NATIONAL BOARD TASK GROUP LOCOMOTIVE BOILERS

AGENDA

Meeting of August 27th, 2020 Virtual Meeting using Zoom

S1.4.2.9 STAYBOLTS

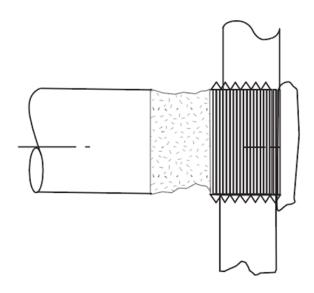
c) Staybolt head flush with or below the surface of the sheet; NBIC Part 2, Figure S1.4.2.9-a

Insert Figure S1.4.2.9-a "Riveted Head Staybolt Dimensions" figure below "g)"

e) Waterside corrosion; NBIC Part 2, Figure S1.4.2.9-b

Insert Figure S1.4.2.9-b "Riveted Head Staybolt Dimensions" figure below Figure S1.4.2.9-a

Item #20-69 Proposal V3

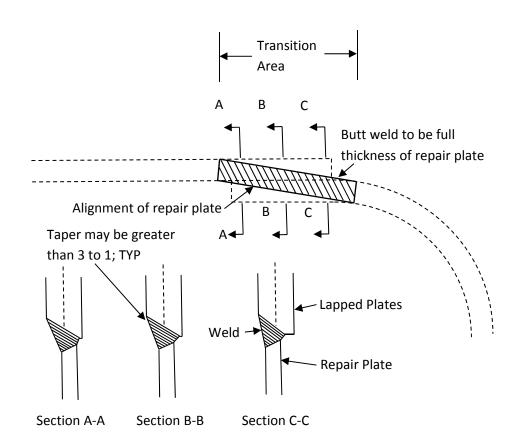
Add a sentence in S1.2.11.5 i); Replace drawing in Figure S1.2.11.5-c1 with new drawing below.

i) For one-piece flange knuckle joint patches in portions of a riveted lap joint or in mud ring corners with a lap joint in the firebox, the knuckle patch shall be supported on at least one of the two planes adjacent to the flange, by means other than the weld. See Figure S1.2.11.5-c1. The weld shall be at least the full thickness of the new plate being installed. Taper of weld in transition area may be greater than 3 to 1. Volumetric examination is not required. This type of repair shall be considered a repair.
